SERVICE BULLETIN

CRACKS, WEAR AND DISTORTION ON THE CARBURETOR FLANGE ON ROTAX[®] ENGINES TYPE 912 AND 914 (SERIES)

SB-912-030 R1

SB-914-019 R1

Fig. 1

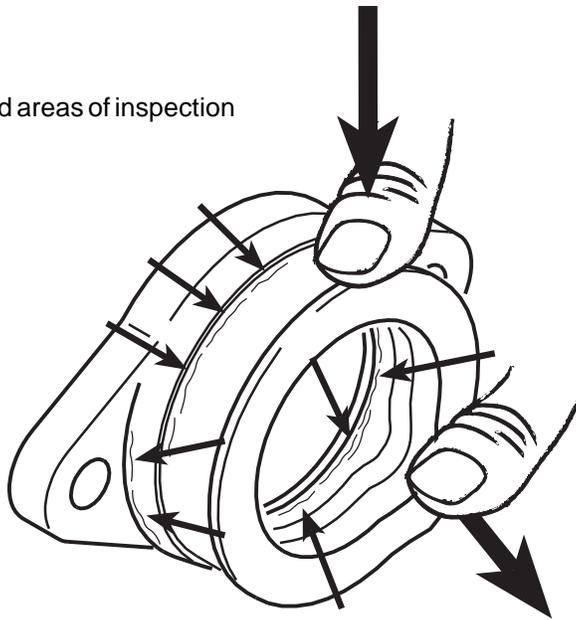
Inspection of the carburetor flanges in accordance with the relevant Maintenance Manual and the information contained in Section 4) Appendix, Figure 1 .

- Within the next 10 hours of operation the carburetor flanges must be inspected for damage, cracks, wear and distortion according to the following instructions in section 3. Replace with part no. 267788 as required.
- Every 50 hours of operation the carburetor flanges must be inspected for damage, cracks, wear and distortion according to the following instructions in section 3. Replace with part no. 267788 as required.

fig. 2

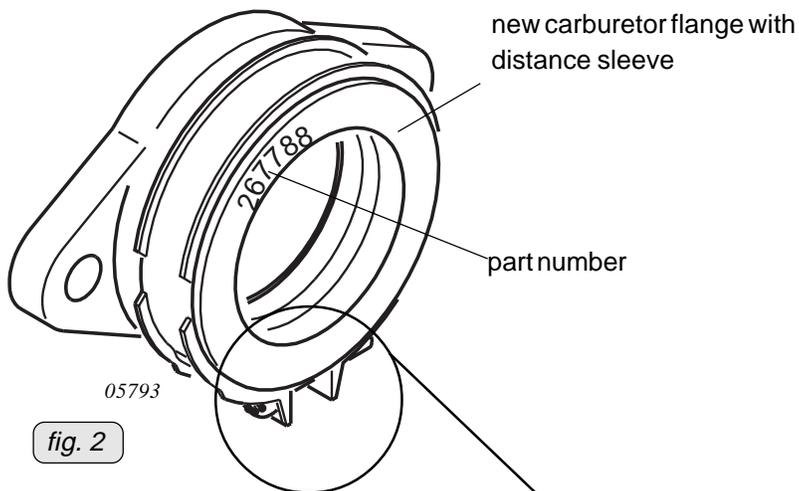
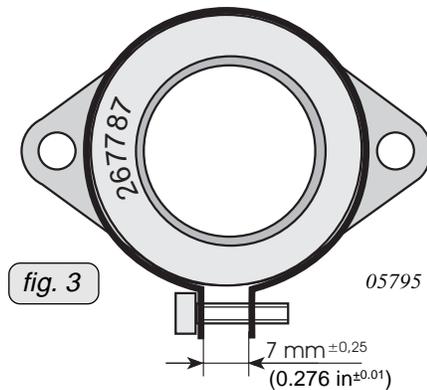
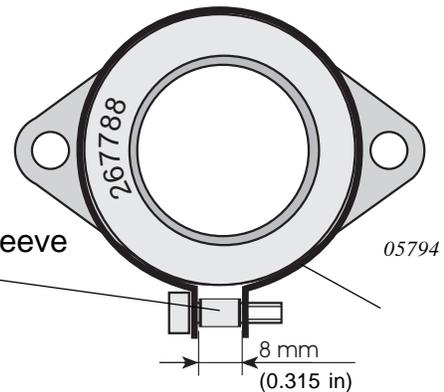
Introduction of a optimized carburetor flange with improved strength properties and spacer for the clamp. One or more of the following could result in increased stress and consequently in damage of the carburetor flange assembly:

* ▲ **WARNING:** Due to differences in spacing **don't use** the distance sleeve (1) included in delivery of the carburetor flange part no. 267788 in combination with the carburetor flange part no. 267787.

▲ **WARNING:** **Don't use** aluminum insert included in delivery of the carburetor flange part no. 267785 or 267780 in combination with the carburetor flange part no. 267788.

- If necessary remove the carburetor flange as per the following instructions.
- If replacement of part no. 267788 is necessary **both** carburetor flange are to be replaced per engine. (Do not mix new style with old style on the same engine)

Fig item no	New part no	Qty per engine	Description	Old part no	application
	267788*	2	carburetor flange assy.	267787	ROTAX [®] 912 / 914
		2	O-Ring47-2	230300

fig. 4

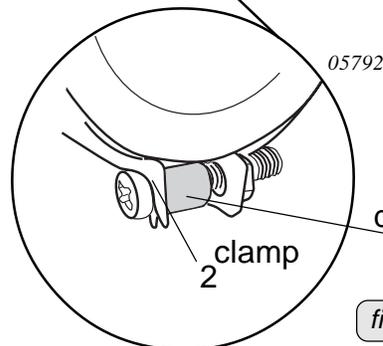
Replacement/Installation of the carburetor flanges in accordance with the relevant Maintenance Manual. Tighten clamp (2) of the carburetor flange part no. 267788 with tightening torque 2.5 Nm (22 in.lb) (see fig. 4) .
